STAFF REPORT

HEARING DATE: April 20, 2021

SUBJECT: H-2020-0123
Movado Mixed-Use

B. Site Plan/New Concept Plan (date: 2/26/2021) NOT APPROVED

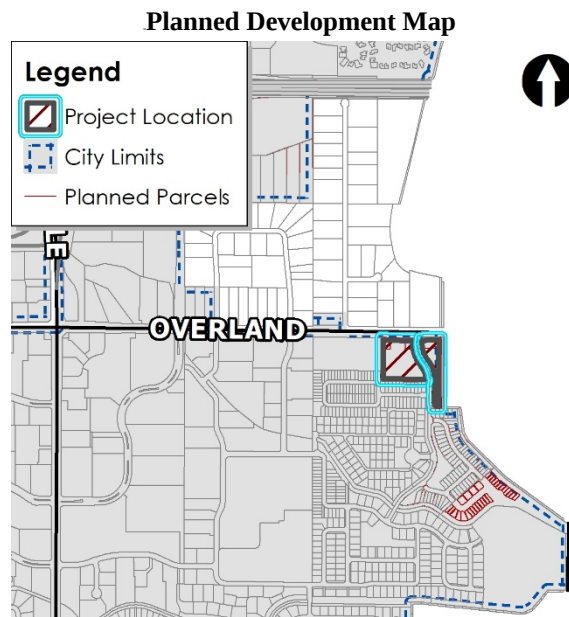
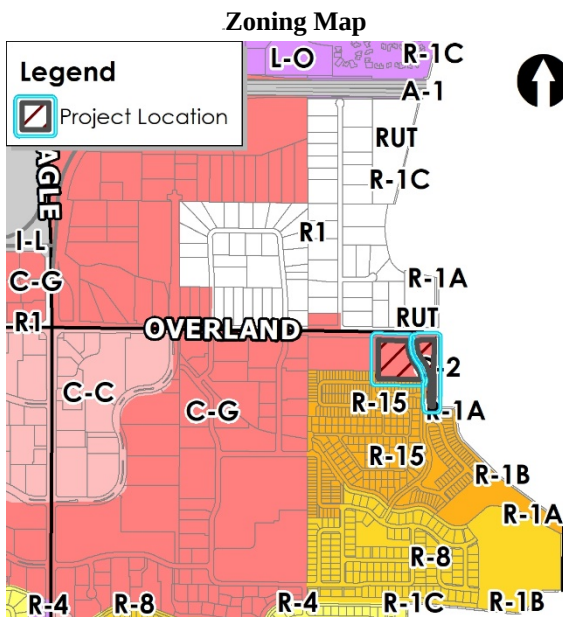
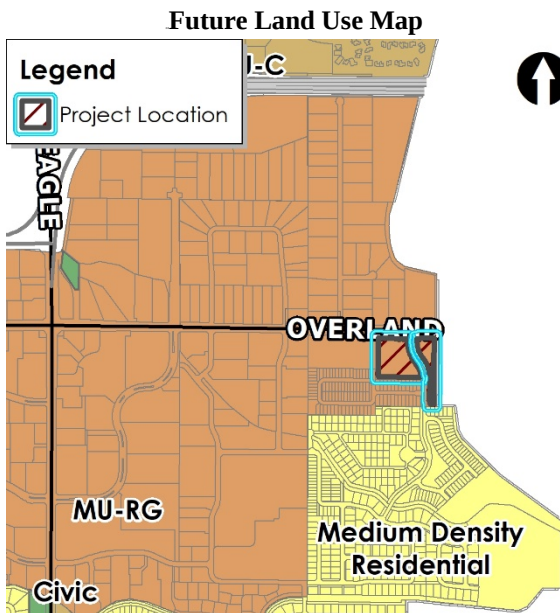
• Impacts/Concerns	• Eliminate water main dead-end at southeast corner of western parcel; possibly run a service line to the building instead. See attached markup.

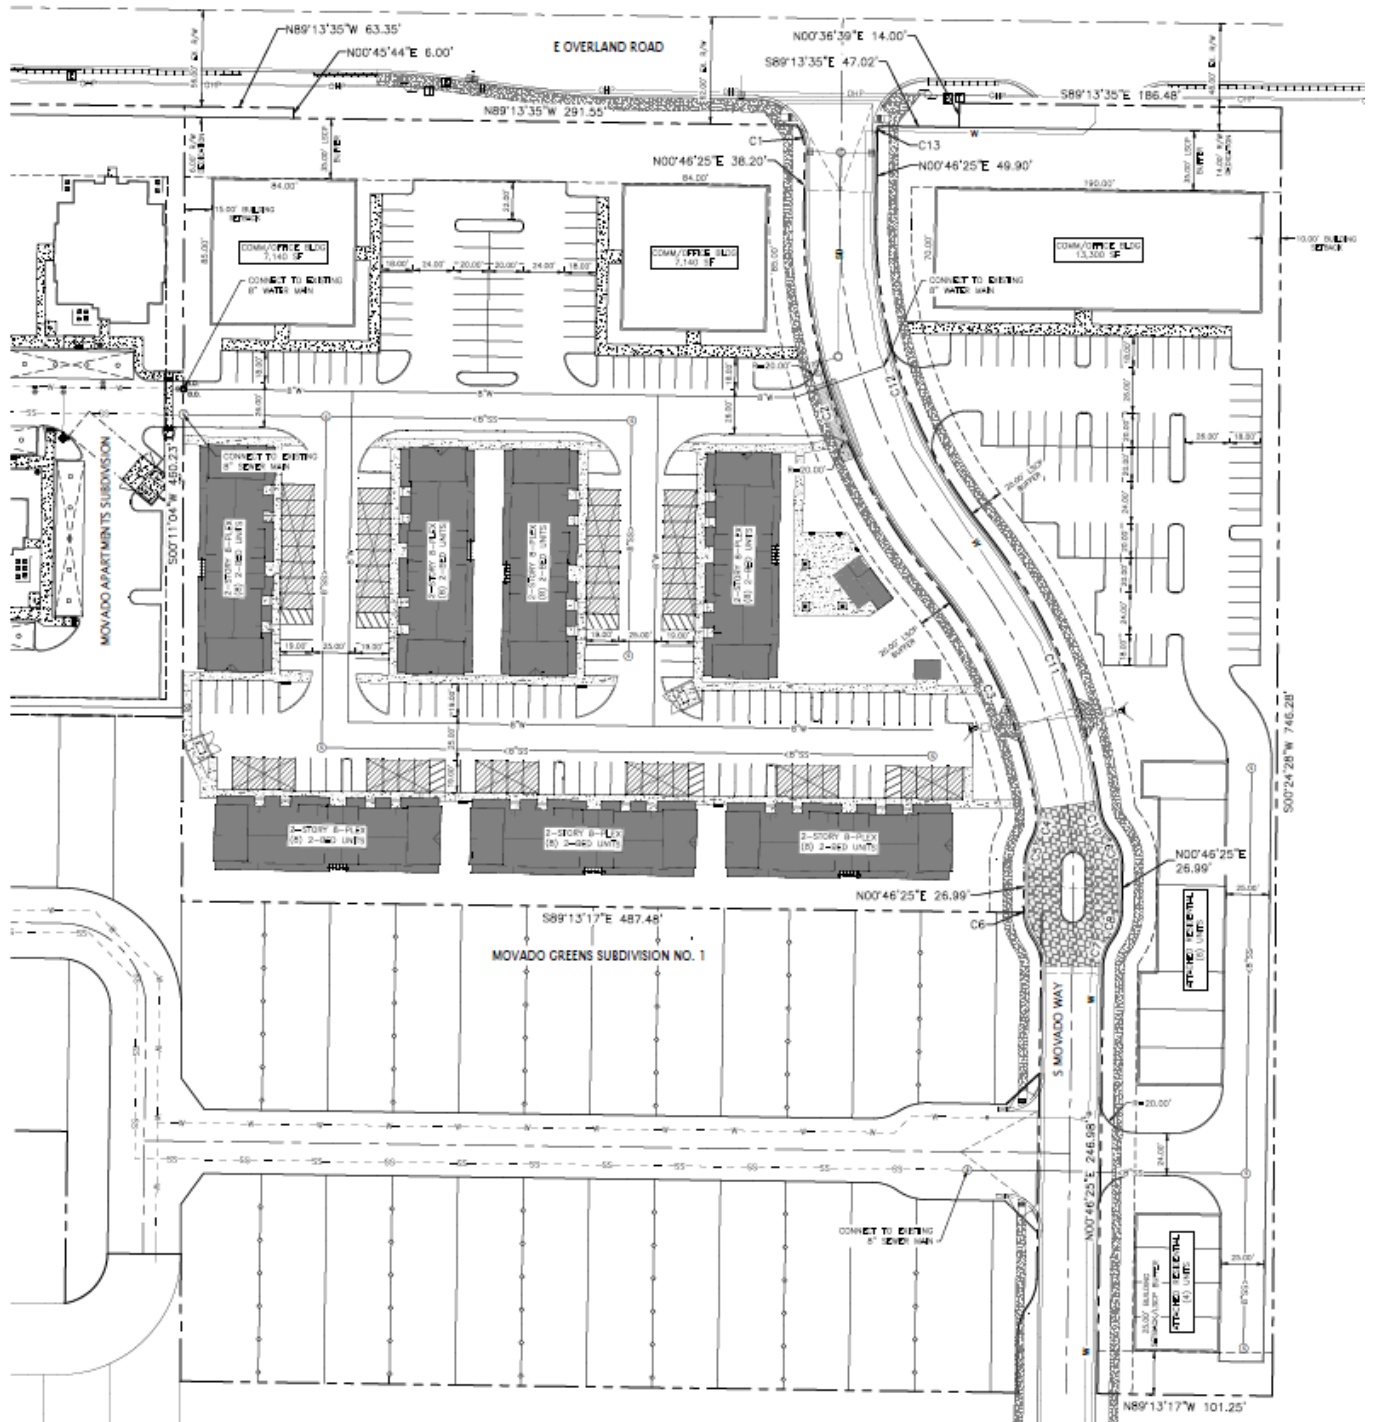
Revising the development plan for this last remaining portion of the Movado Estates development is doable if done so with the right changes in mind. Staff believes that what the Applicant has presented does not fully touch on what a mixed-use development can provide, especially in terms of creating a sense of place and providing more pedestrian focus. Staff recommends some revisions to the site plan to improve the integration of uses and to better create a sense of place in this portion of the Movado development overall. Staff's recommended changes are as follows: condense the northwest commercial into one building; widen the northernmost drive aisle and include street trees while removing all parking that backs into the driving lane; and, incorporate a shared plaza between the commercial and residential.

First, the Applicant should lose the northwest commercial lot in lieu of providing a plaza for the multi-family residential and future commercial to share. Instead of two single-story commercial buildings, the Applicant should consolidate these buildings into one structure that is two-stories in height in order to better utilize the land area available. In addition, constructing a two-story structure can hold the corner

The final piece of this revision relates to the design of the shared drive aisle. With the removal of parking spaces along the drive aisle, the drive aisle can be widened to accommodate detached sidewalks and street trees lining both sides of the drive aisle to create a short boulevard. Across this boulevard is where the new pedestrian pathway should be constructed; the crossing should be constructed with a different material than that of the driving surface (i.e. stamped concrete, pavers, or similar) to clearly delineate the pedestrian path between the residential and commercial. An additional option for this drive aisle would be to include parallel parking spots with detached sidewalks and appropriate landscaping (street trees are not a requirement but a recommendation). With Staff's recommended revisions, Staff supports the Development Agreement Modification request.

- i. ~~Condense the two commercial buildings on the western parcel into a singular two-story structure;~~
 - ii. ~~Remove the parking along the northernmost east-west drive aisle on the western parcel to allow for detached sidewalks on both sides with 8-foot wide parkways and street trees;~~

- iii. Add a shared plaza to be used by the commercial and multi-family residential within the development located somewhere within the area of the proposed commercial buildings along Overland—conceptual design of this area should be completed by the Applicant and submitted to Planning Staff for review prior to the City Council hearing;

2. The Applicant shall adhere to all previous conditions of approval associated with this site (H-2016-0112 & H-2017-0104).
3. **At least ten (10) days prior to the City Council hearing, the Applicant shall submit a revised site plan and landscape plan to reflect Staff's recommended layout changes above and the following dimensional standard revisions:**

- i. **Revise the drive aisle in the southeast corner of the western parcel to reduce this segment's length to no more than 150 feet.**
4. At least ten (10) days prior to the City Council hearing, the Applicant shall submit a revised open space exhibit showing the ten (10) units in the southeast corner of the development and compliance with the multi-family open space standards.
